#### APPEAL SUMMARY

<b>Appeal ID:</b> 24389	<b>Project Address:</b> 5210 N Kerby Ave
<b>Hearing Date:</b> 11/25/20	<b>Appellant Name:</b> Andrew Pearson
<b>Case No.:</b> B-009	<b>Appellant Phone:</b> 503-902-6983
<b>Appeal Type:</b> Building	<b>Plans Examiner/Inspector:</b> Jeff Rago
<b>Project Type:</b> commercial	<b>Stories:</b> 4 <b>Occupancy:</b> E and A <b>Construction Type:</b> III-A and I-A
<b>Building/Business Name:</b> Jefferson High School	<b>Fire Sprinklers:</b> Yes - All except cafe, auditorium, aux gym, locker rooms
<b>Appeal Involves:</b> Alteration of an existing structure	<b>LUR or Permit Application No.:</b>
<b>Plan Submitted Option:</b> pdf [File 1] [File 2] [File 3]	<b>Proposed use:</b> Education (K-12 school)

## APPEAL DECISION

Sheet Title:  
BASEMENT  
FIRE LIFE  
SAFETY PLAN

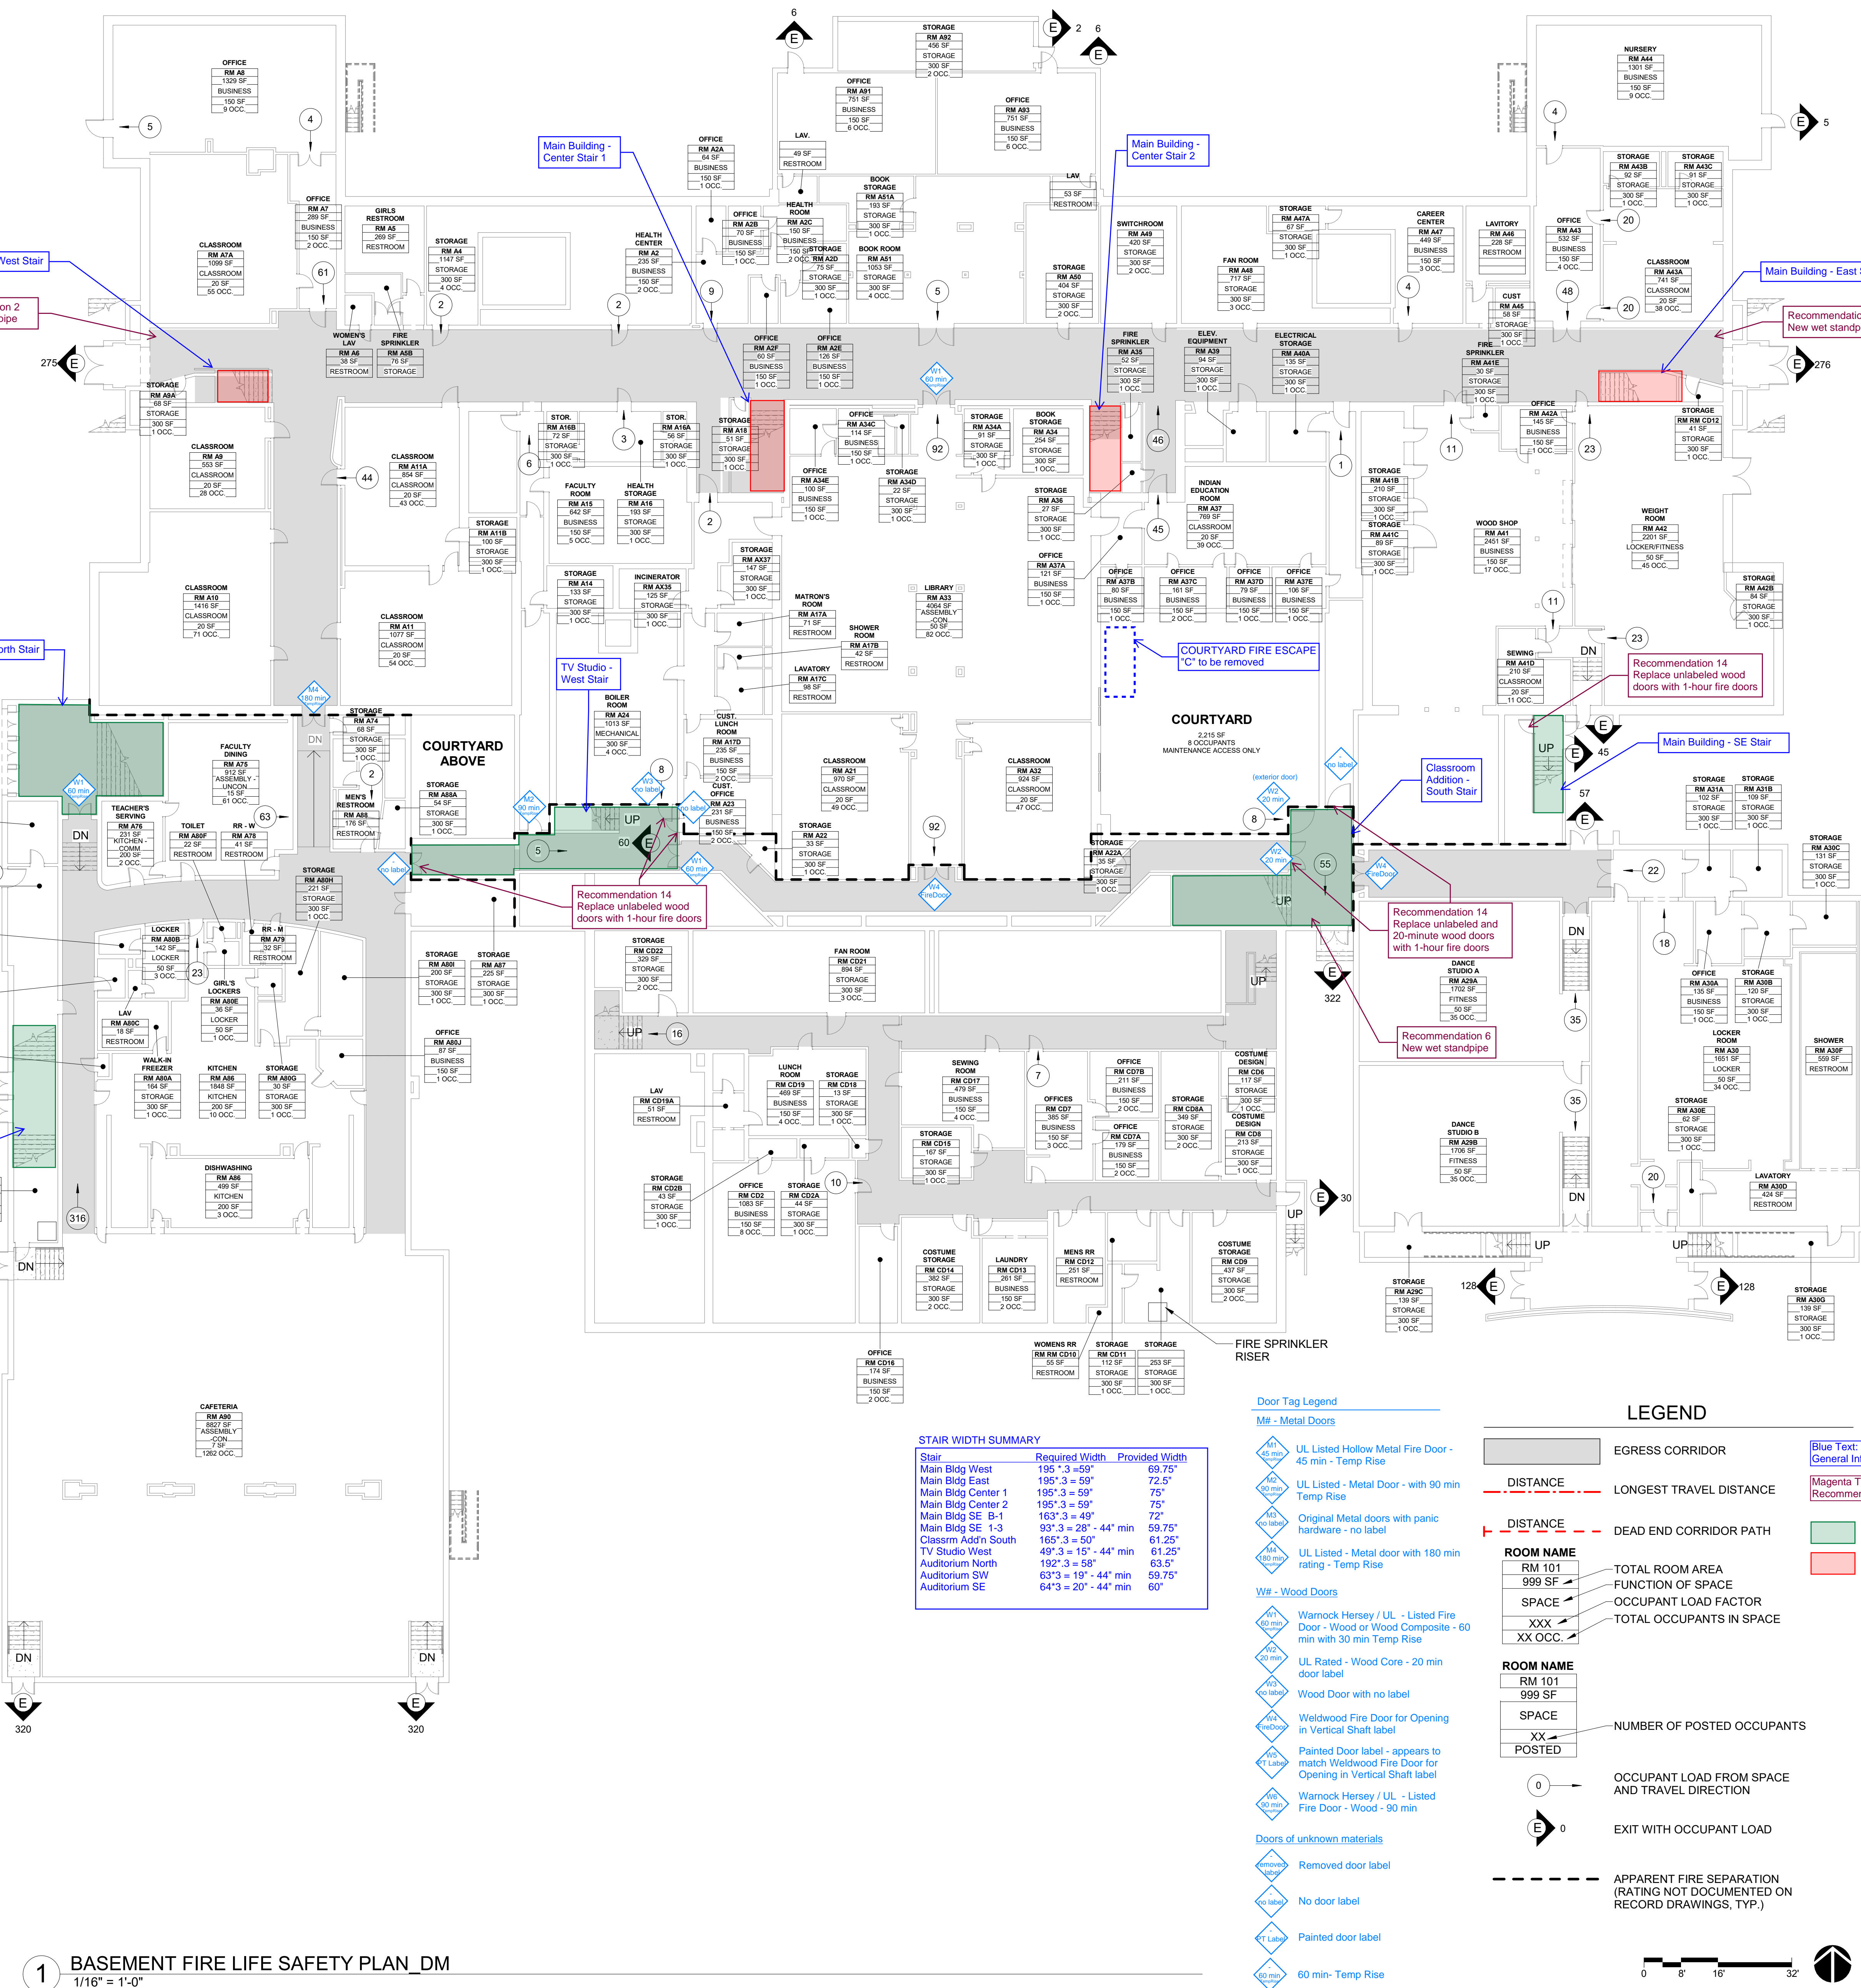
**1. Protection of East and West open exit access stairs with draft curtains and closely spaced sprinklers: Hold for additional information.**

**2a. Removal of two exterior dry standpipes adjacent to Fire Escape A & B with replacement by interior wet standpipes: Hold for additional information.**

1 FIRST FLOOR FIRE LIFE SAFETY PLAN\_DM  
1/16" = 1'-0"

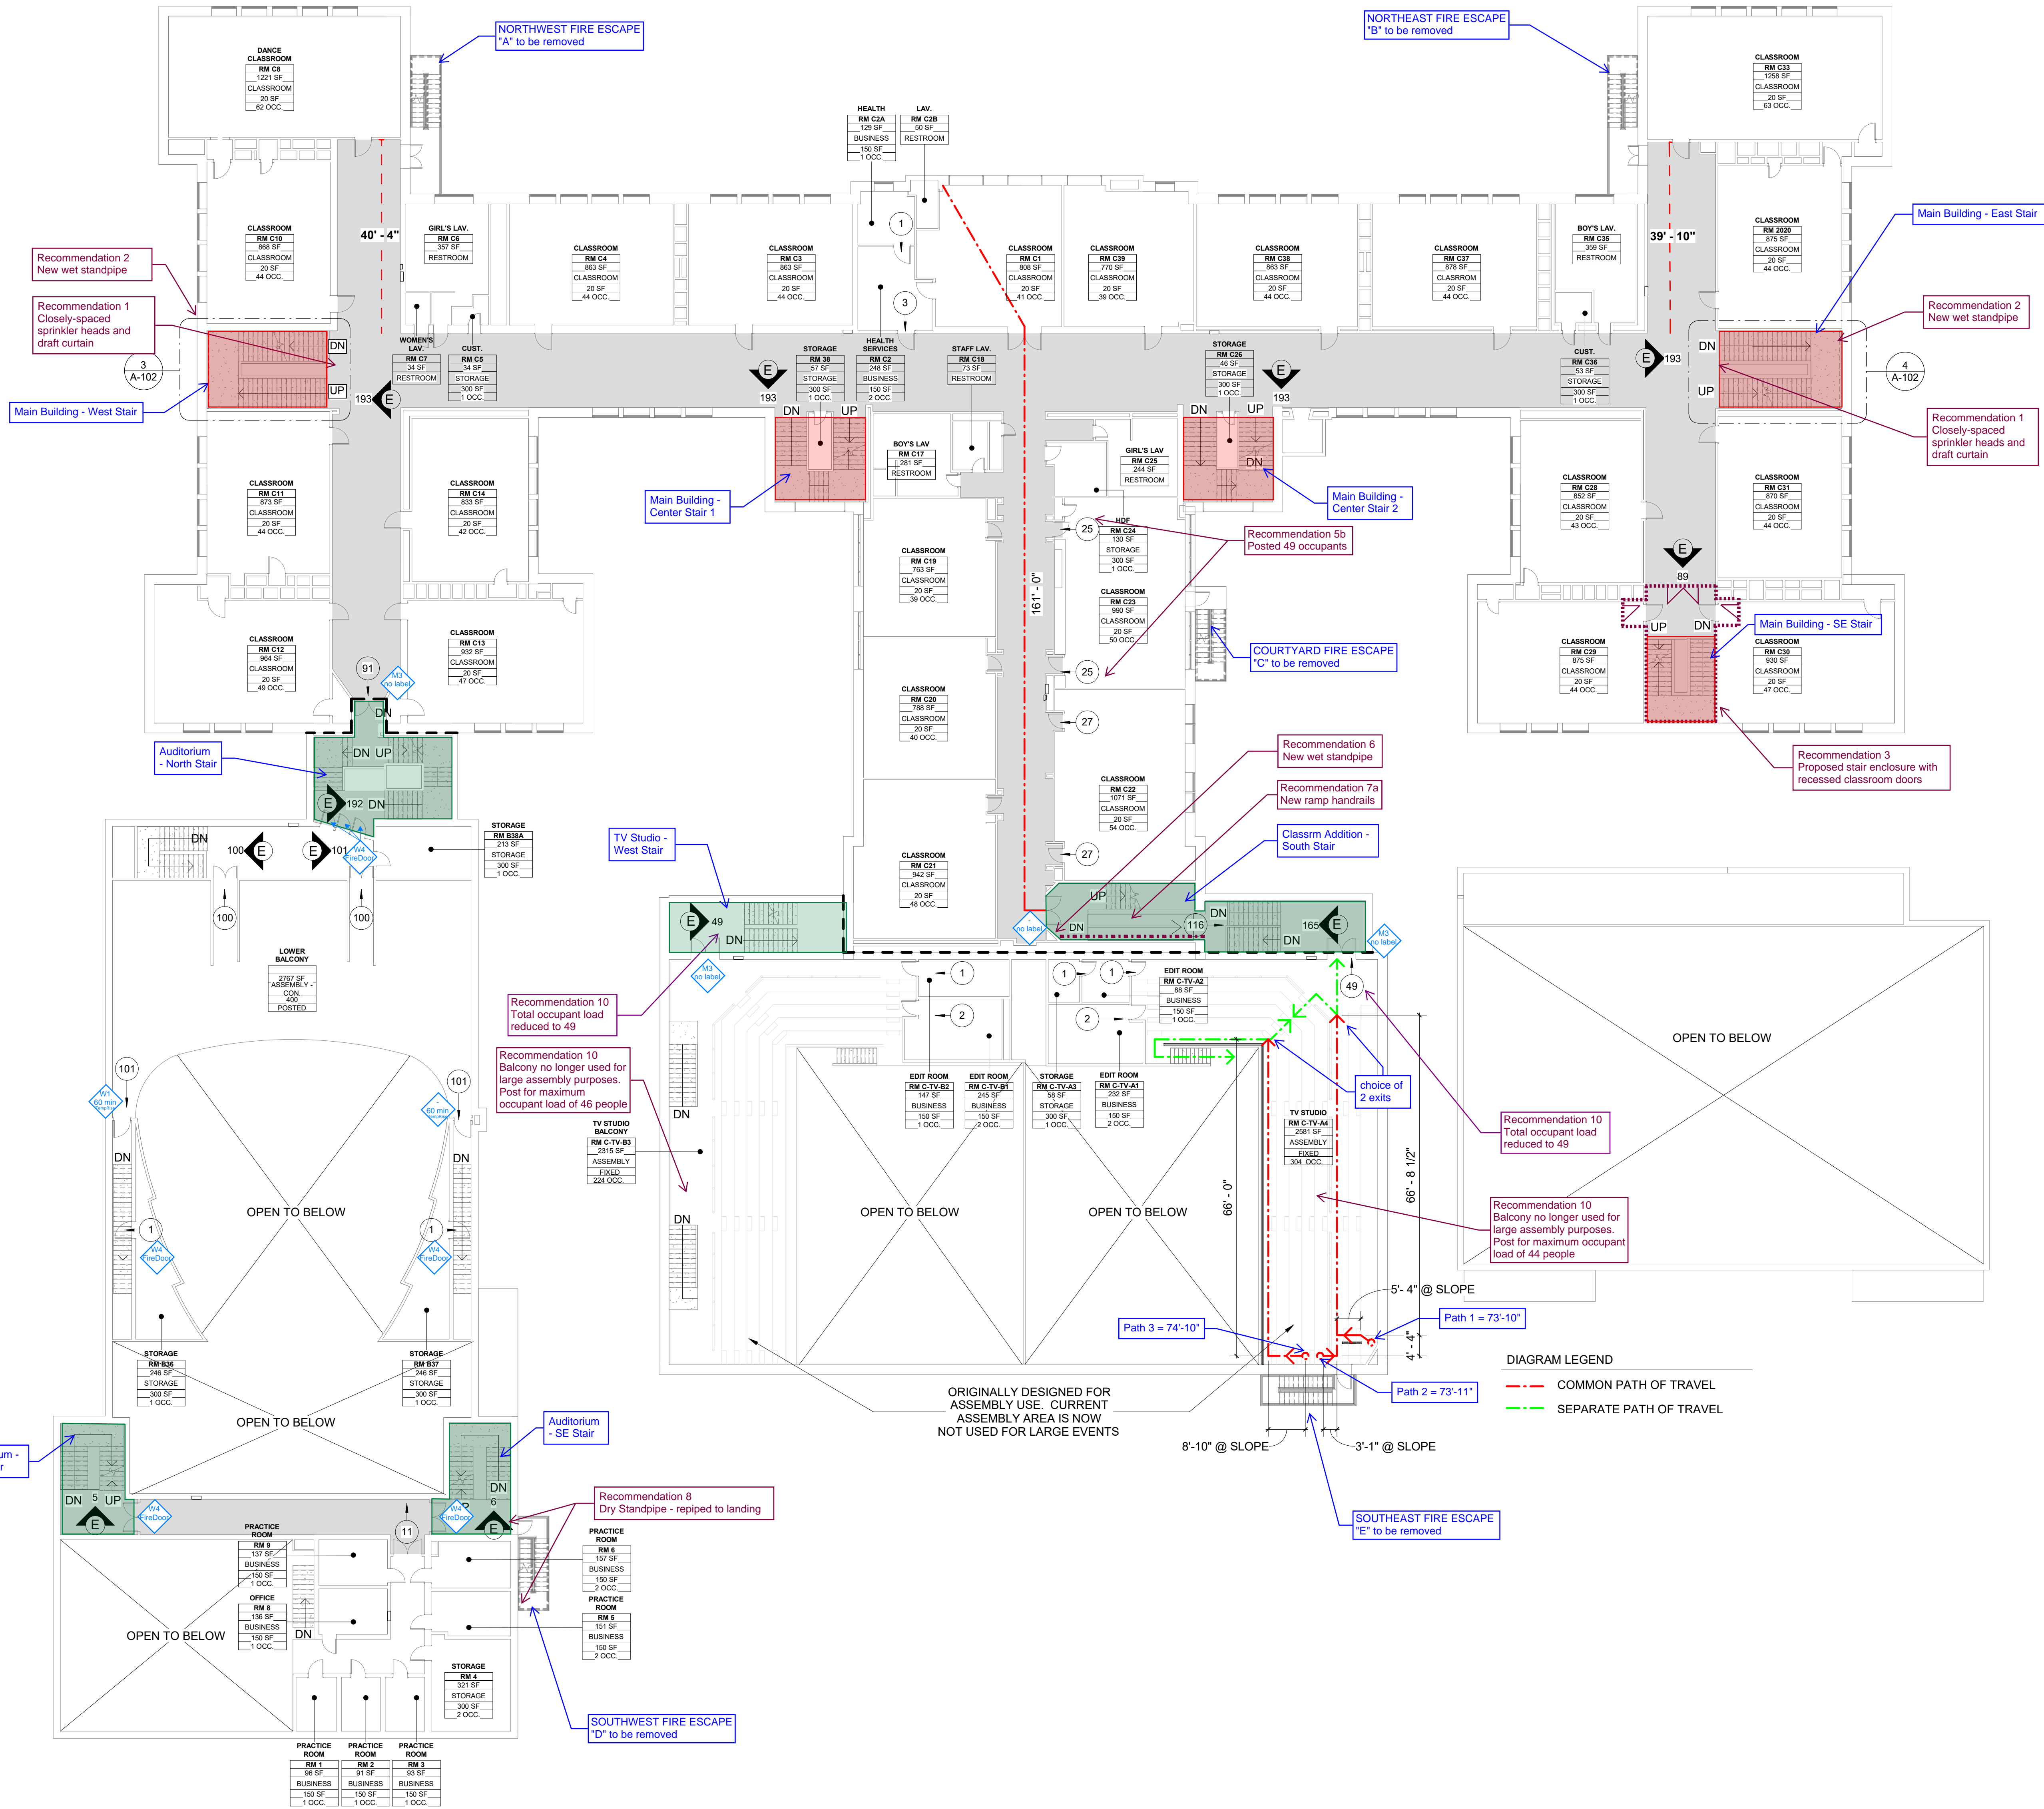
Construct a stair enclosure at the Main Building southeast stair connecting floors 1 through 3, and recess two existing classroom doors on each floor so that they do not protrude into the egress path. Existing partitions and plaster finishes in the stairway, which cannot be verified to be fire rated, will remain, as will the existing wood-framed floor at the bottom of the stair on the first floor. New construction will be 1-hour rated per the requirements of 2019 OSSC section 1023.2 for interior exit stairways connecting three floors. See Recommendation #3 on attached Code Evaluation Memorandum and Fire Life Safety Plans.

Install a 1 hour fire-rated pair of cross-corridor doors at an existing opening on the first floor between the Main Building and the Auxiliary Gym Addition. These doors will include electronic hold-opens connected to the fire alarm system. Installation of these doors will complete enclosure of the Main Building southeast stair and connect it to an existing enclosed stair leading from the first floor directly to the exterior at the basement level. See Recommendation #4 on attached Code Evaluation Memorandum and Fire Life Safety Plans.
